## STAFF REPORT

### Community Planning and Preservation Commission Certificate of Appropriateness Request

Case No.:	19-90200040
Address:	634 Roser Park Drive South (Park Area)
Legal Description:	ROSER PARK PARK AREA, DESC AS BEG SE COR LOT 4 BLK 1 ROSER PARK TH S 60FT(S) TH SE 370FT (S) TH E 110FT(S) TH S 175 FT (S) TH SW 20FT (S) TH N R/W ROSER

Parcel ID No.: 30-31-17-76914-001-0050  
Date of Construction: 1920s  
Local Landmark: Roser Park Historic District (HPC 87-01)  
Owner: City of St. Petersburg  
Request: Review of a revision to a previously approved Certificate of Appropriateness for the construction of a permanent art installation in the north creek bank parkland, between 7<sup>th</sup> Street South and 6<sup>th</sup> Street South, consisting of five sculpted disks. Each sculpture is approximately 40 inches tall by 42 inches wide.

# Previously Approved

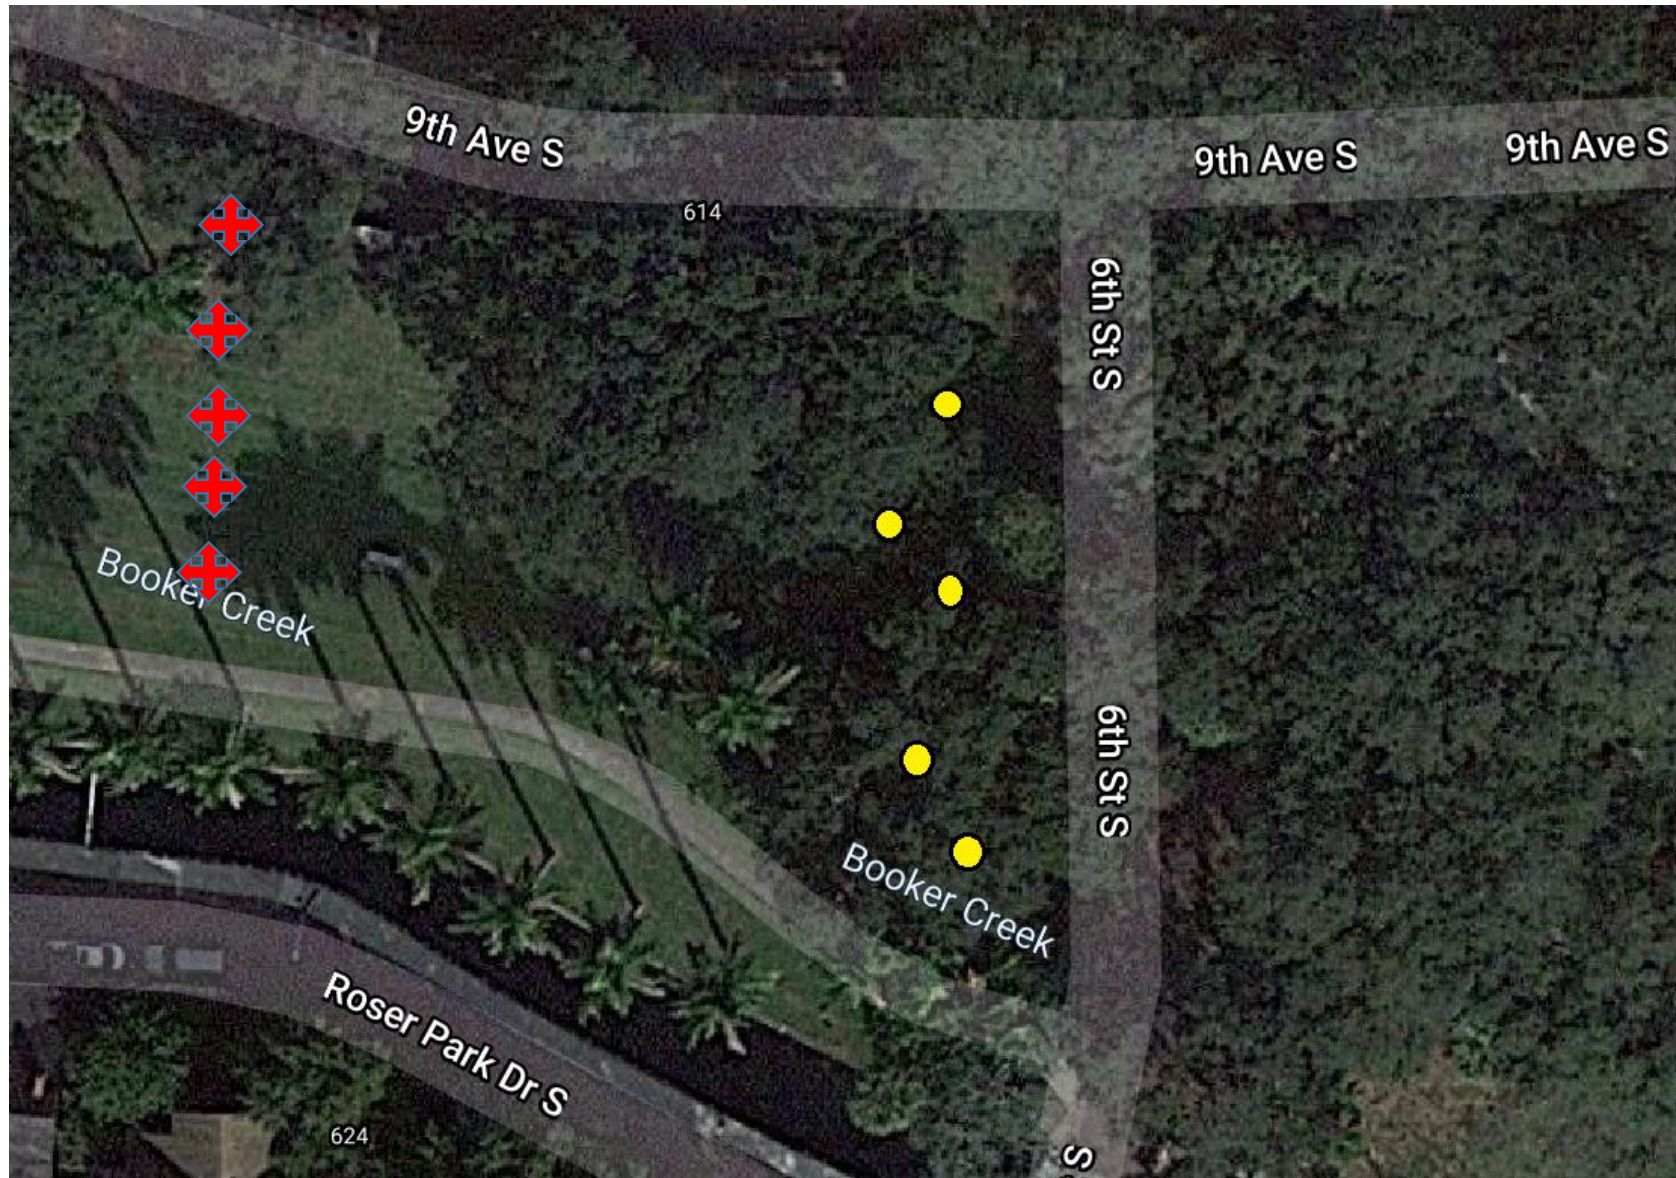
PREVIOUS CPPC APPROVAL: 1) LOCATION APPROVAL WITH SIZE MODIFICATION AND 2) COA EXTENSION

REQUEST: MODIFICATION TO CERTIFICATION OF APPROPRIATENESS FOR NEW LOCATION WITHIN THE PARK

REASON: EROSION NEAR THE CHANNEL WALL IN LINE WITH PREVIOUSLY APPROVED LOCATION.

# Jeff Whipple Sculptures for Roser Park Layout

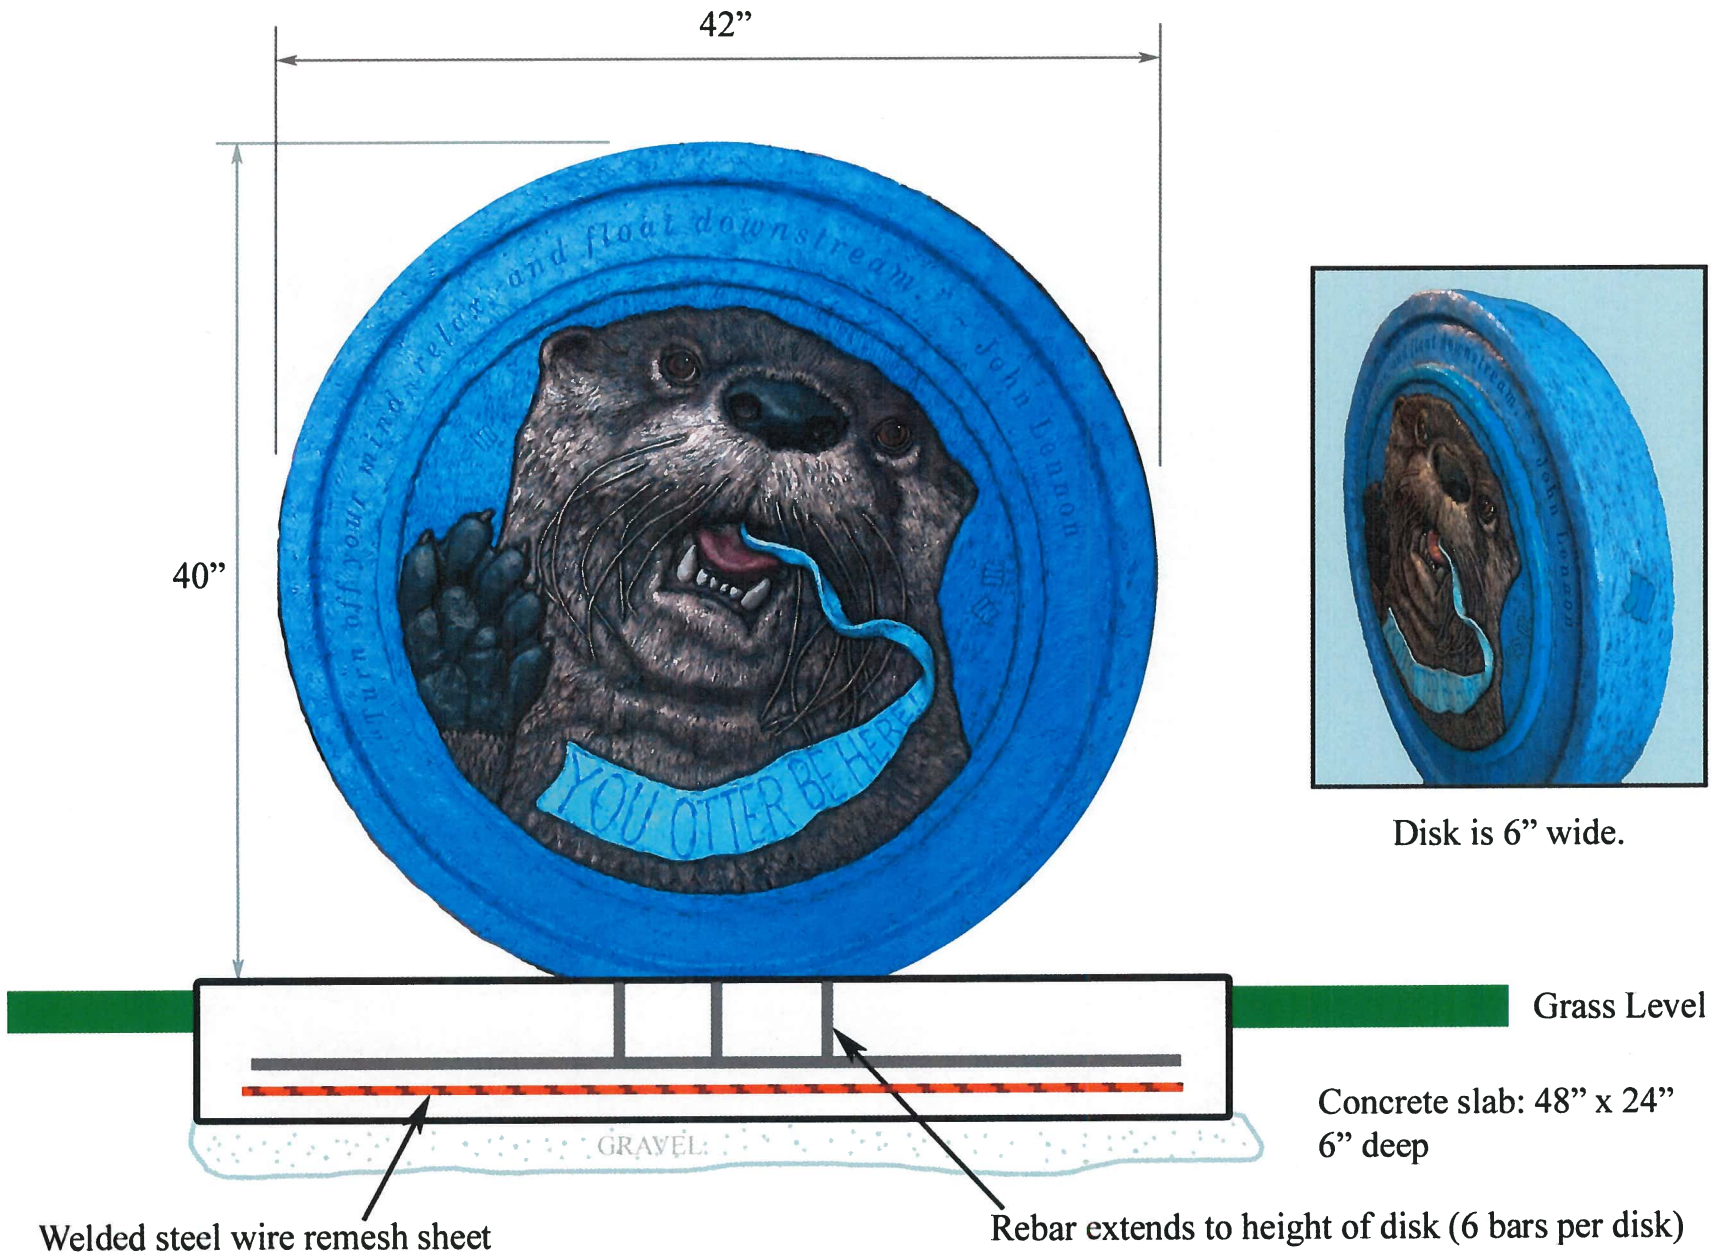
The five sculptures will be placed 14 feet apart from near the curb at 9th Ave. S. down the hill to 20 feet above the walkway along Booker Creek. None of the sculptures are located near a tree.
